Marge Schmuckal - permit for new sun room

64 Brook Rd

2013-01339

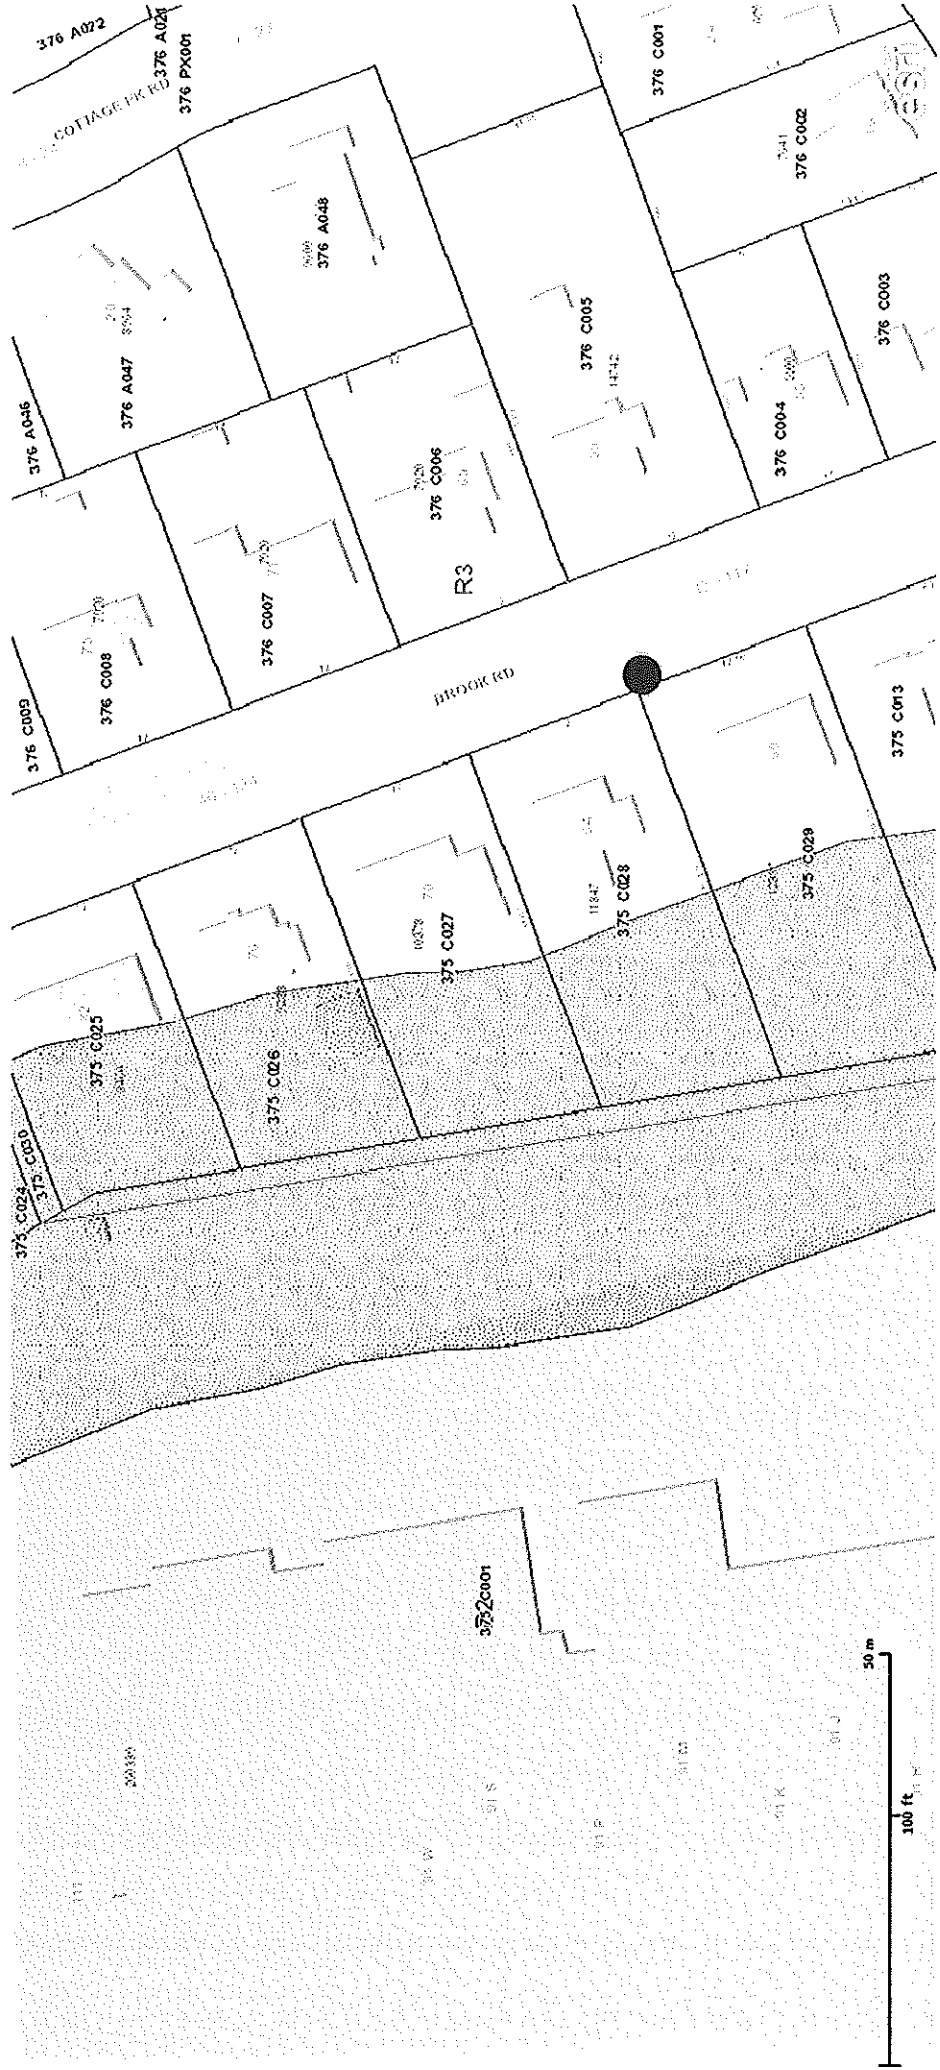
I am in receipt of your application to build a new 11'3" x 18' sunroom on the rear of your house. Please note that your property abuts the Fallbrook River and is covered by a 75' setback from the high water line from the edge of the stream toward your house. There is a requirement that no structure be located within that 75' stream protected area. I will need a better plot plan by a professional who can delineate where that stream and 75' setback is on your property and how it relates to your new sun room. Your permit will be on hold until such time a new site plan is submitted. Please submit any new plans to the same web site that your originally submitted your application.
